City of West Linn
PRE-APPLICATION CONFERENCE
SUMMARY NOTES

August 19, 2010

SUBJECT: Removal of existing boat ramp/dock facility and construction of a single 240 foot long dock and 130 foot long launching ramp, plus additional grading and driveways at the Cedaroak Boat Ramp (4600 Elmran Drive)

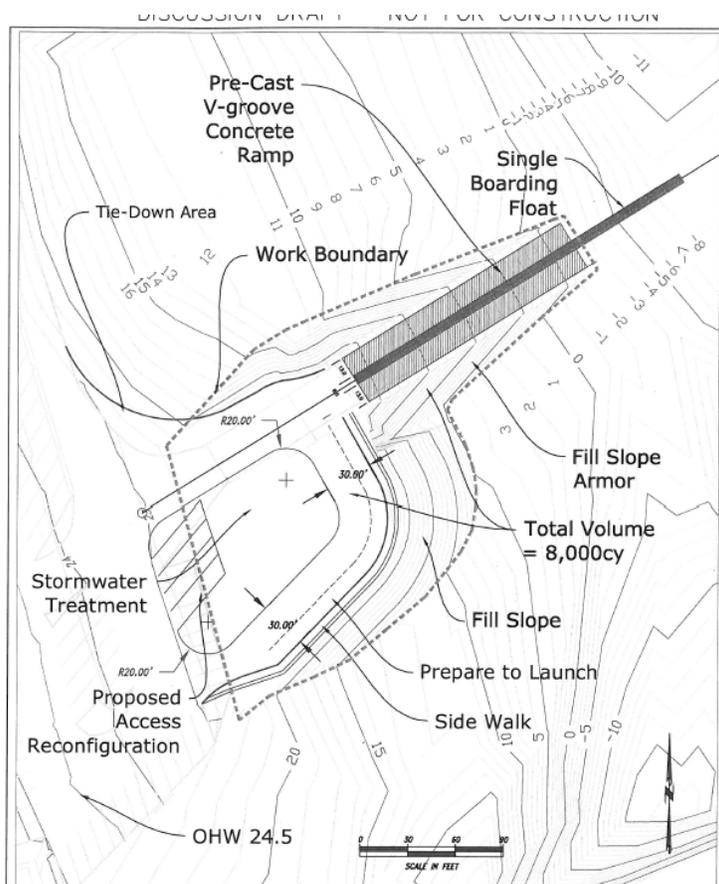
Initial staff concerns include:

- The fill and longer dock will likely hasten accretion, both upstream and downstream of the fill, resulting in reduced water/channel depths.

- Potential impact on fisheries through the loss of riparian functions and increased potential for storm runoff and associated pollution, displaced nearshore habitat typically used by migrating and rearing fish.
- Obstructing the historic and safe navigation of the channel to the south.
- Changes to hydrology and pattern of floodwaters.
- Unbalanced cut (dredge) and fill.
- Significant loss of riparian vegetation and trees that typically support terrestrial and aquatic species, including a high Habitat Conservation Area (HCA)
- Water quality issues.

Cedar Island

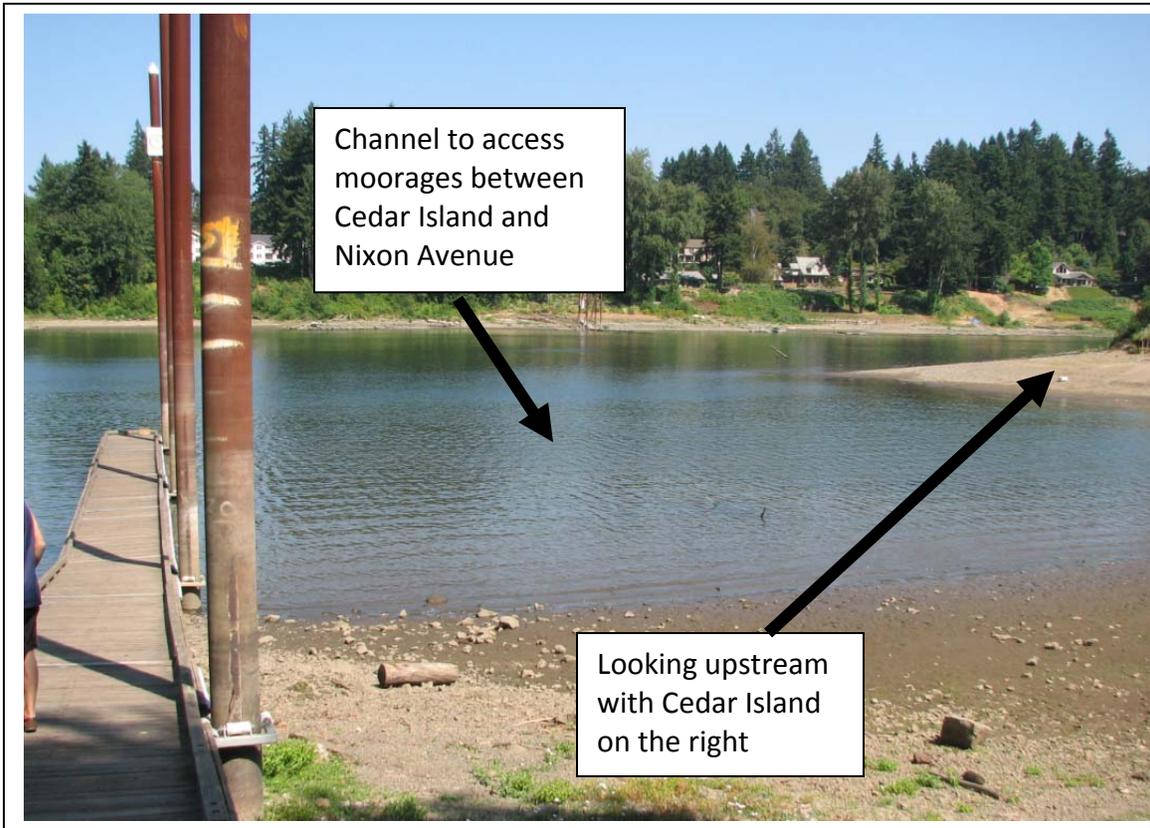
The concern is that accretion and the dock extension may make it difficult to access the channel west of Cedar Island which is used by dozens of boat owners along Nixon Avenue. Downstream accretion could be a problem too.

Another issue that staff will be considering is the effect of the dock extension on the navigability of the channel to the south of the dock between Cedar Island and the mainland. Currently this channel is the only year round route to get to and from the main body of the Willamette River from moorages at the rear of properties along Nixon Avenue. Accretion (sand and silt deposits) is already building up at the north end of the

island to the extent that the navigable passage is limited. There are at least 15 private docks on that channel. Blocking historic, safe and uninterrupted passage is prohibited per 28.050(A) (4). The Parks Department should be able to show that reasonable passage to and from this channel is not compromised by the fill and dock extension. Similar concerns exist regarding the effects of littoral drift caused by the extended dock and ramp upon downstream docks. The Parks Department should also be able to explain why dredging was not proposed despite the fact that the CDC endorses dredging over extension.
